PREVOST

**SAFETY
RECALL**

SR13-61

DATE :	NOVEMBER 2013	SECTION :	13 – Wheels & Tires
SUBJECT :	DOT Certification Plate for M455 Wide Base Single Tires

Fig.3 Typical DOT certification plate

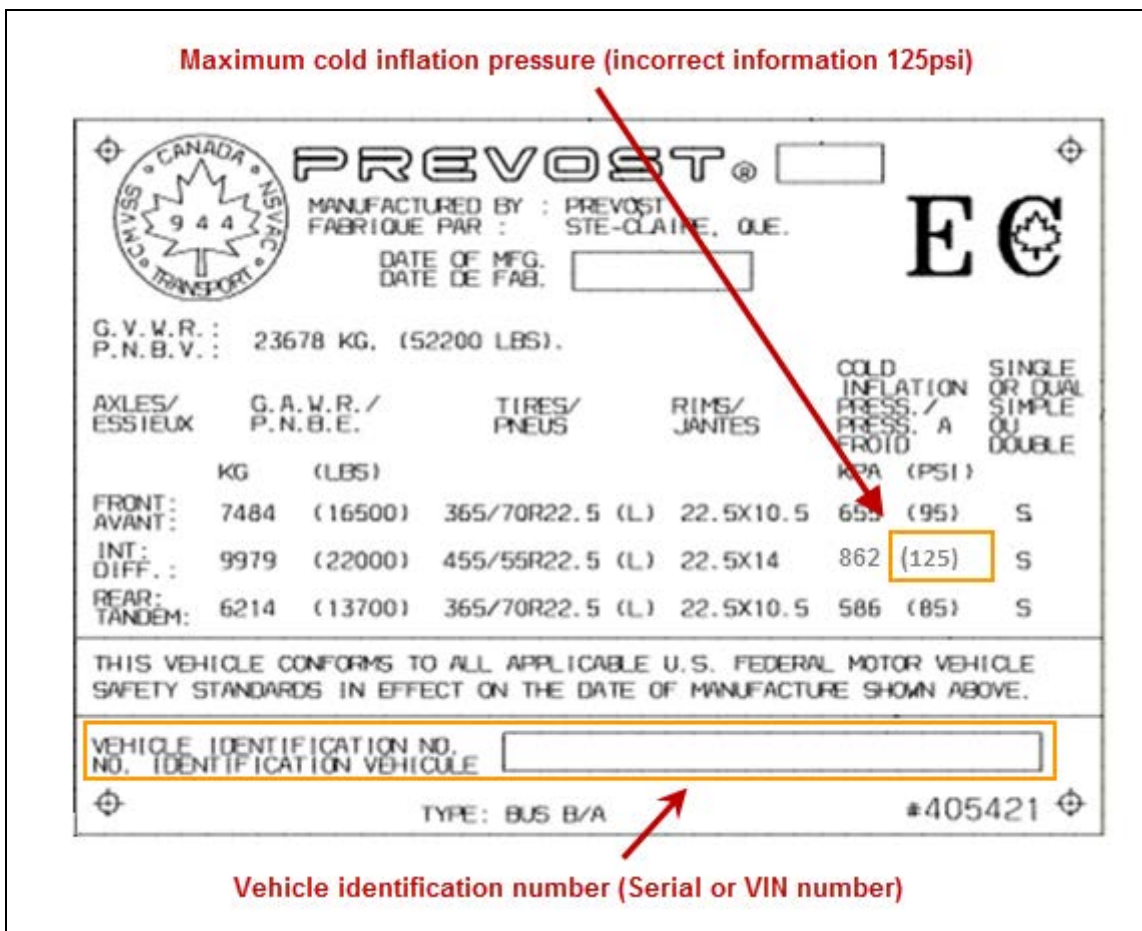
On vehicles affected by this recall, the DOT (Department of Transportation) certification plate displays an incorrect maximum cold inflation pressure for the Michelin 455/55 R22.5 type "X One Super Single" Wide Base Single Tires.

Specifically, the plate displays a maximum of 125psi (862kPa) instead of the 120psi (827kPa) specified by the manufacturer.

2. On the DOT Certification plate, locate the following information (Fig.3).
 - Incorrect maximum inflation pressure on the drive axle (validation).
 - Vehicle identification number (VIN).

To ensure vehicle conformity, the DOT plates must be replaced and recovered by a certified Prevost Service Center. The vehicle tires cold inflation pressure must also be verified and lowered to the recommended manufacturer specification as required.

3. Contact your nearest PrevoSt Service Center to proceed to the plate replacement (specify recall SR13-61). Each plate is individually serialized, the Service Center will need the complete vehicle identification number (VIN) to order the correct replacement plate (Fig.3). Allow 3 to 5 business days for delivery of the new plates.
4. On the vehicle drive axle, verify that the original equipment Michelin X One XDN2 “Super Single” tires are not inflated beyond the 120 cold psi recommended by the manufacturer (Fig.4 and 5 below).
5. Lower the tire pressure as required.

Fig.6 Vehicle Identification Number and Plate number

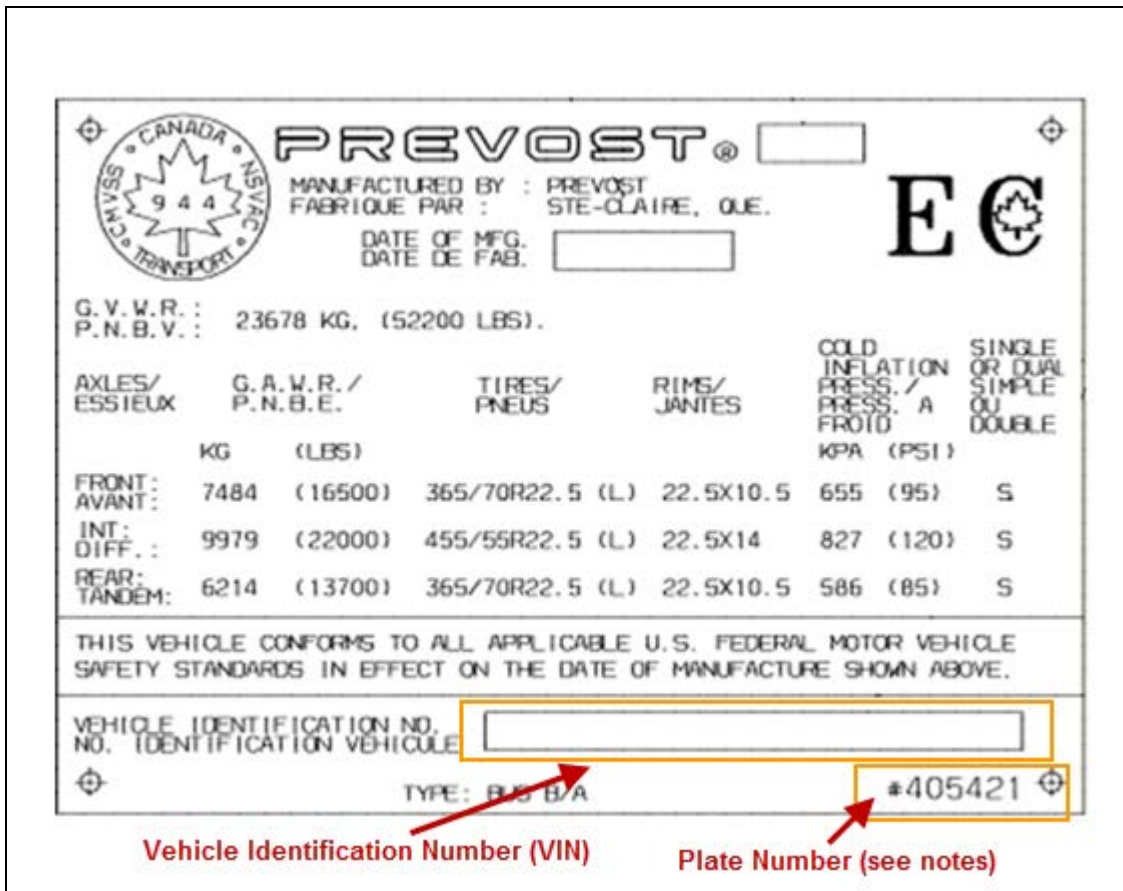
1. Order a *DOT certification plate* at the Prevost Part Center using the vehicle identification number (VIN).
2. Upon receipt of the new plate, validate the information below :
 - The vehicle identification number on the plate matches the vehicle number.
 - The plate type number (lower right corner) Fig.6 matches the old plate number (see below for exceptions).

NOTE: The two (2) following plates are now obsolete; a replacement plate will be substituted following the chart below.

Original Part #	Statuts	Replacement Part #
408303	Obsolete – DOT Certification Plate X3-45	405421
408342	Obsolete - DOT Certification Plate X3 VIP	408340
